ADDENDUM NO. 2

DATE: October 28, 2016
PROJECT NAME: Gallup Skatepark
FORMAL BID NO.: 1624

DRAWING SHEET
LD101

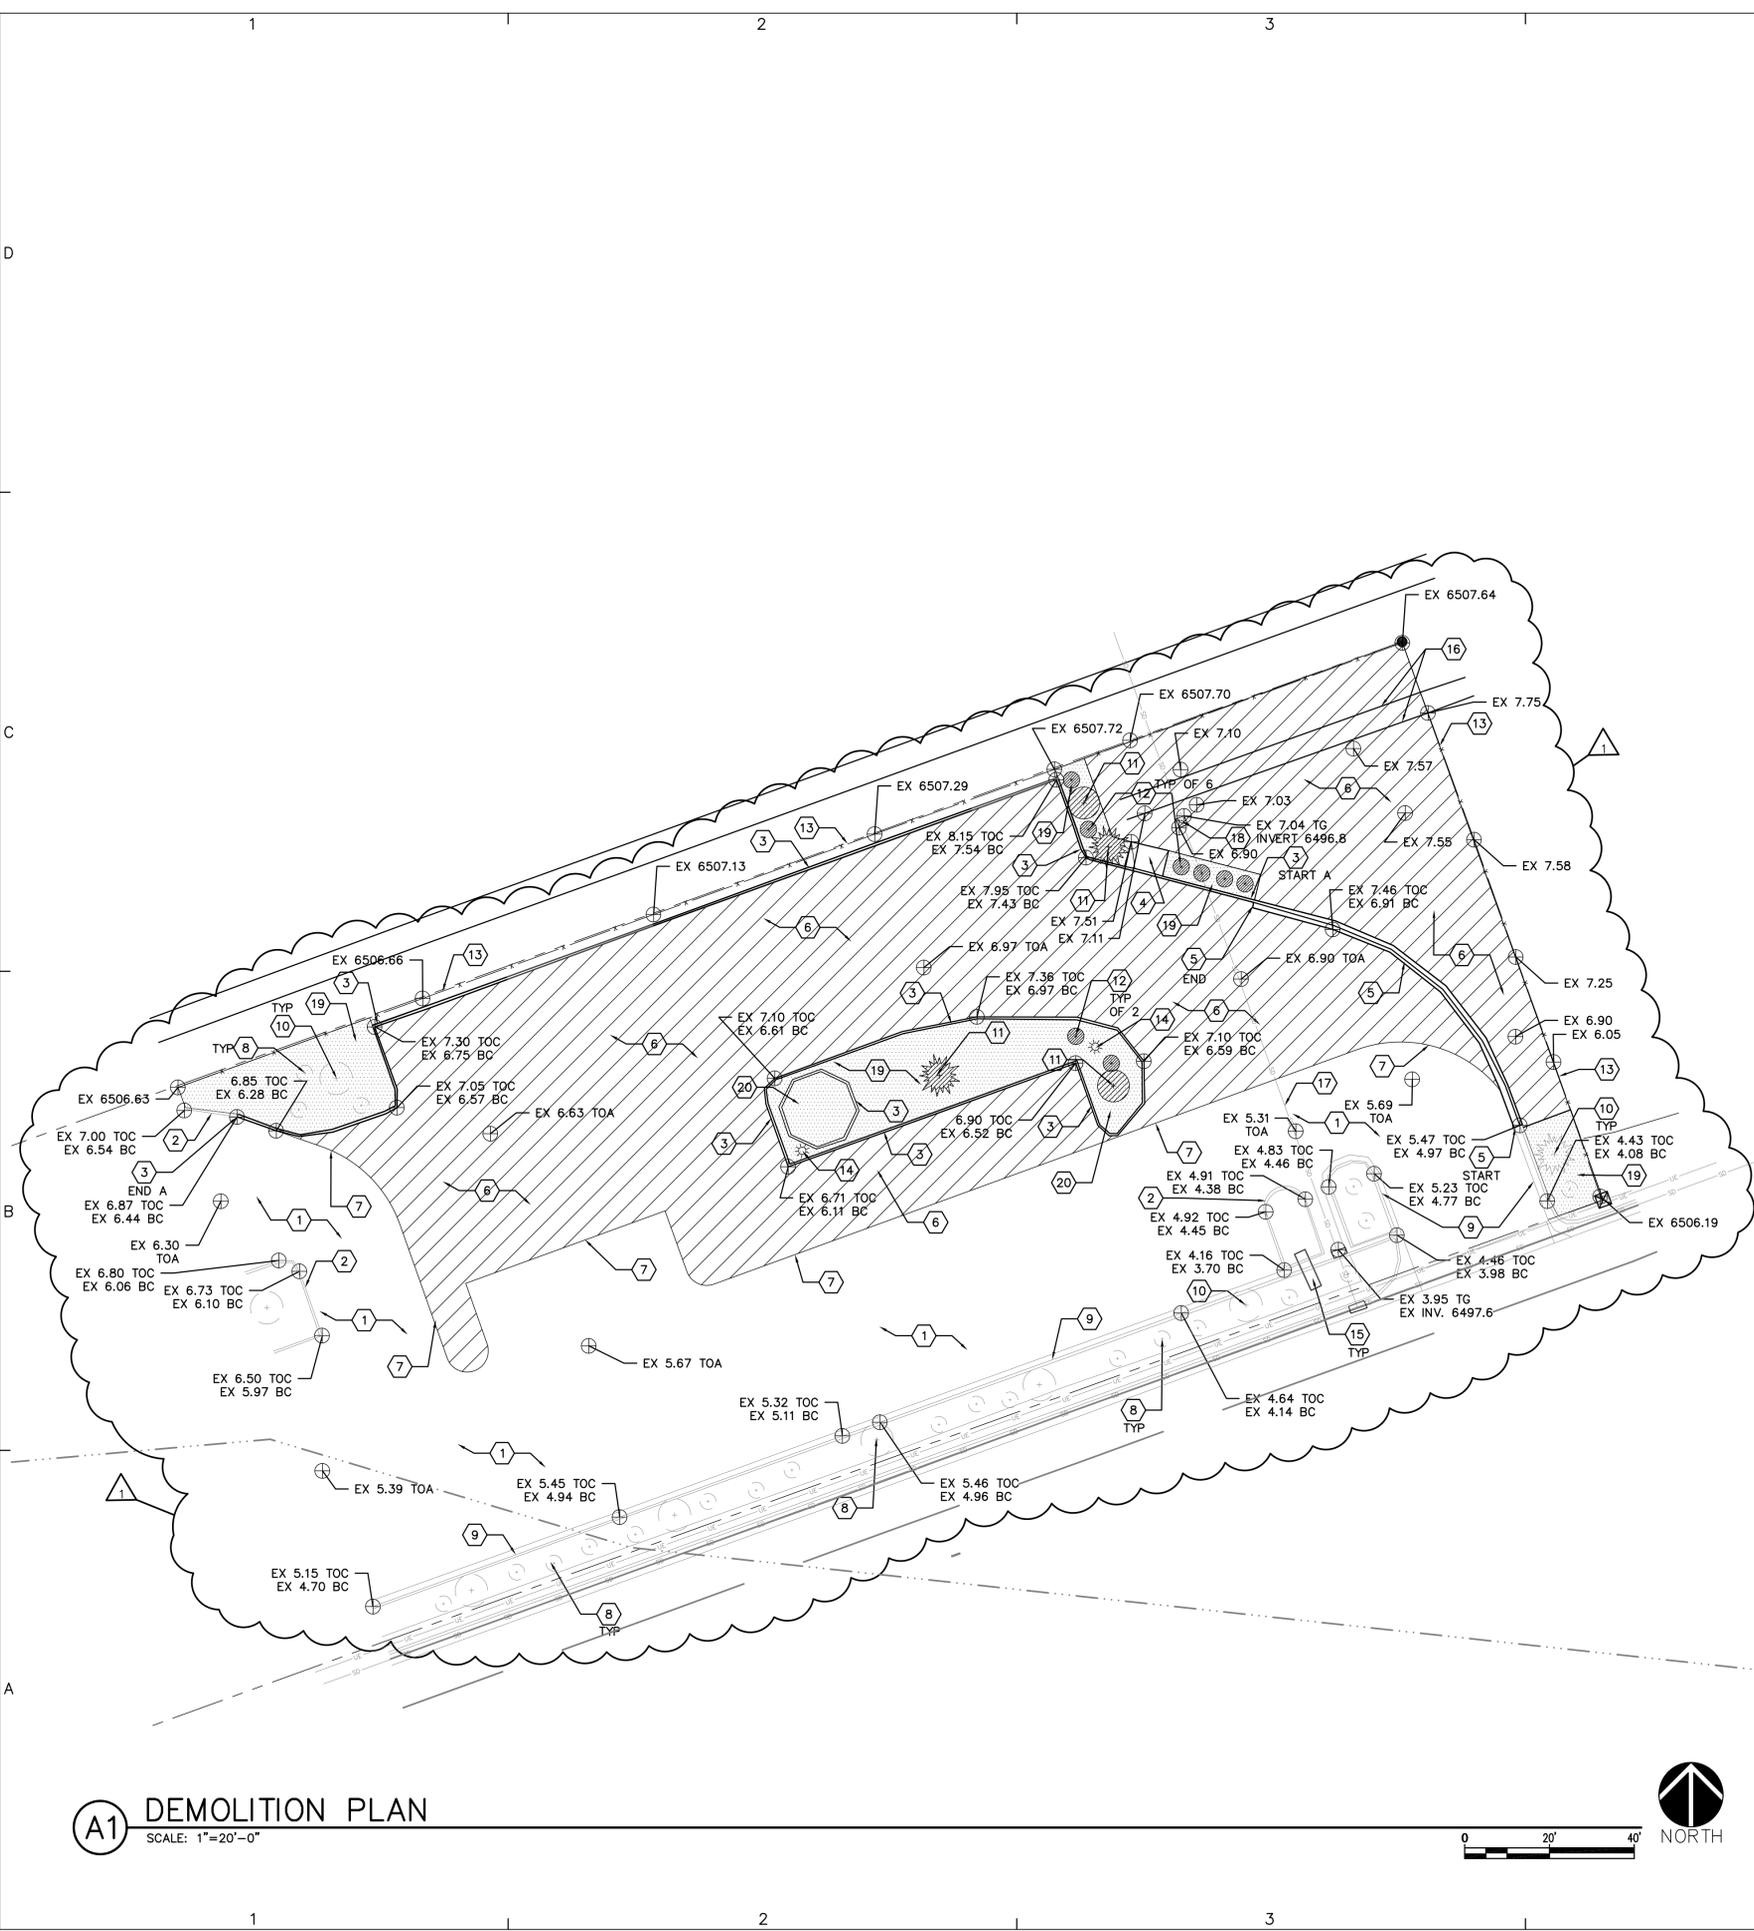
1. DEMOLITION PLAN SHEET LD101: Delete Sheet LD101 in its entirety and replace with the attached Sheet LD101. The plan is revised to show existing spot elevations and revised limits of asphalt removal (page 7 of 10).
2. CONSTRUCTION PLAN SHEET LS101: Delete Sheet LS101 in its entirety and replace with the attached Sheet LS101 (page 8 of 10).
 - a. The plan is revised to show spot elevations on the curb and other site features.
 - b. Construction Keyed Note #12. Add to the description “The existing storm drain line is concrete with an approximate inside diameter of 4’7”. Invert elevations are shown on the Demolition Plan Sheet LD101. A manhole is not required at the point of connection to the storm drain line.”
 - c. Construction Note B. Add to the note “Locally sourced tan or gold gravel is an acceptable substitution to ‘Canyon Gold’.”
